SB369D-200 SB369F-078

SERVICE BULLETIN

DATE: 7 APRIL 2000

LANDING GEAR STRUT INSPECTION AND FAIRING MODIFICATION

Figure 1. Landing Gear Strut Inspection Hole

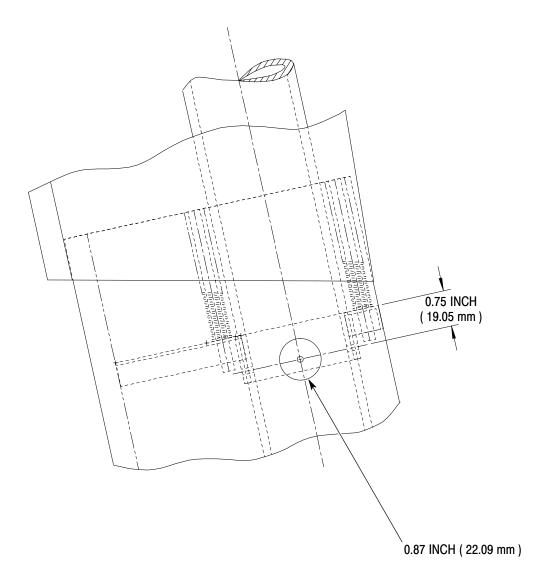
- (2). Remove 369H6200-23 and -24 support assemblies.
- (3). Clean and dye penetrant inspect 0.125 inch (3.18 mm) diameter hole in inboard surface of 369H6001-31, -32, -51, or -52 strut assemblies as shown in CSP-IPC-4, Section 32-10-00 and Figure 1.

- (4). If a crack is found, replace strut assembly. If no crack is found, continue with rework.
- (5). Ream hole to 0.132 inch (3.35 mm) diameter to provide smooth (63 RMS) surface. Leave hole open and apply chemical coating to bare metal.

- (6). Drill 0.87 inch (22.09 mm) diameter hole through aft fairing in line with 0.132 inch (3.35 mm) diameter hole in strut as shown in Figure 1.
- (7). Seal exposed edges of composite fairings using adhesive. Touch-up finish to match aircraft finish. Install HS4248-C56 button plug in hole.

(6). Drill 0.87 inch (22.09 mm) diameter hole through fwd fairing assemblies in line with 0.132 inch (3.35 mm diameter hole in strut.

Figure 2. Landing Gear Modification

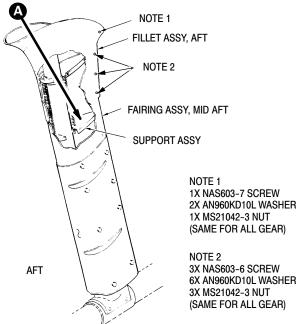
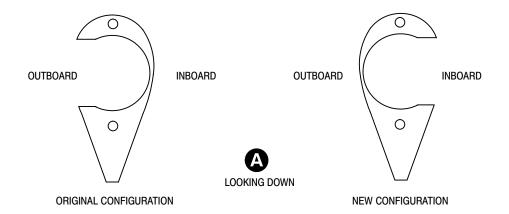
Procedures in this Bulletin provide owners and operators with information pertaining to exchanging the left and right-hand landing gear fairing support assemblies (leaving the inboard fairing support rivet holes open), inspecting each rivet hole for cracks, and modifying each fairing to allow for future inspection of the rivet holes without removing the fairings.

NOTE: Refer to CSP-HMI-2 and CSP-IPC-4, Section 32-10-00 for illustrations and part number callouts and Figure 1 and Figure 2 for location of inspection hole and fairing/fillet rework/installation.

NOTE: Refer to CSP-HMI-2 and CSP-IPC-4, Section 32-10-00 for illustrations and part number callouts and Figure 1 and Figure 2 for location of inspection hole and fairing/fillet rework/installation.
